Technical Service Bulletin

NUMBER: 21-011-01

NV247 Transfer Case Seepage

1999 - 2000 WJ Grand Cherokee

FIGURE 1 - REAR RETAINER HOUSING

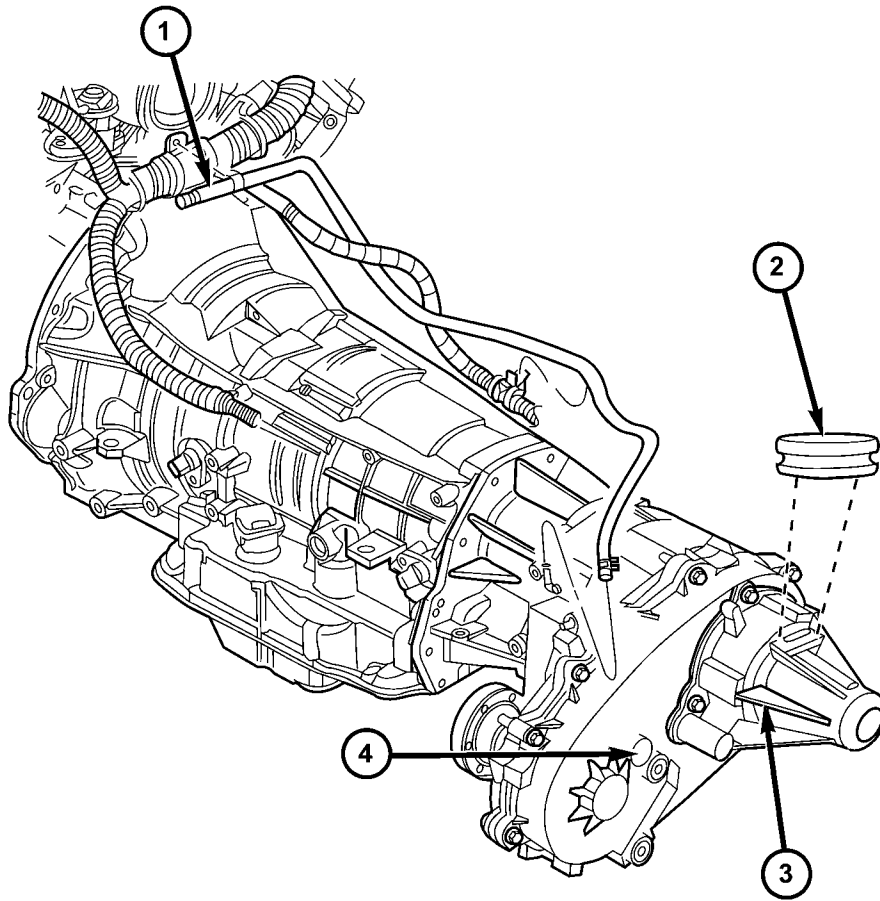
This bulletin involves replacement of the rear retainer snap ring access plug and transfer case vent cap and, resealing of the transfer case rear retainer housing.

4. The vent hose is located above the transmission housing near the back of the engine. It is trapped under the dipstick tube mounting bracket. From below, pull the hose out from under the bracket and down to a workable area on the passenger side of the transfer case (Figure 1).
5. Cut off the end of the hose just below the vent cap housing and remove the band clamp from the cut end of the hose.
6. Insert the new Jiggle Cap vent (PN J5352955) into the end of the hose.
7. Re-align the vent hose with the dipstick tube housing and tie wrap it to the dipstick tube just below the dipstick tube mounting bracket.

11. Remove the propeller shaft.
12. Remove the four rear retainer housing mounting bolts.
13. Remove the rubber snap ring access plug on the top side of the rear retainer housing (Figure 1).

18. Using the alignment marks previously made, install the propeller shaft, torquing the bolts to 18.9 Nm (14 ft. lbs.)
19. Using NV247 Transfer Case Fluid (PN 05016796), check and refill the transfer case to the proper level (fluid should be able to be touched by a fingertip inserted into the fill hole on the transfer case.)(Figure 1).

14. Using an appropriate tool, spread the rear bearing locating snap ring and remove the rear retainer housing.
15. Clean the mating surfaces of the rear retainer housing and the transfer case and apply new Mopar RTV Sealant (PN 04883971).

16. Spread the rear bearing locating snap ring and install the rear retainer housing on to the transfer case.
17. Torque the four rear retainer housing bolts to 33.9 Nm (25 ft. lbs.)

20. Install the new rubber rear retainer snap ring access plug (PN 05018919AA.)
21. Lower the vehicle and close the hood.
